Gatwick Airport Northern Runway Project

The Applicant's Response to Deadline 4 Submissions

Application Document Ref: 10.38

Figure 1: Hydrograph to show River Mole flow rates

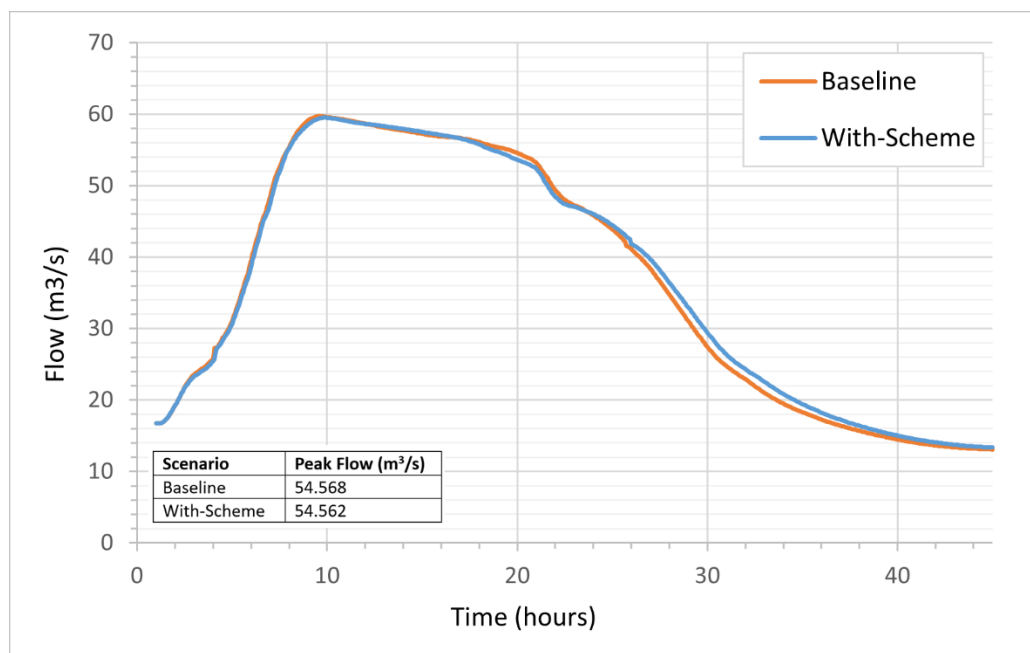
3.5.21 In relation to water supply, GAL submitted to examination as part of their responses to actions arising from ISH7 the email from Sutton and South East Water confirming they can meet the additional water demand from the Project at Deadline 4 [\[REP4-037\]](#).
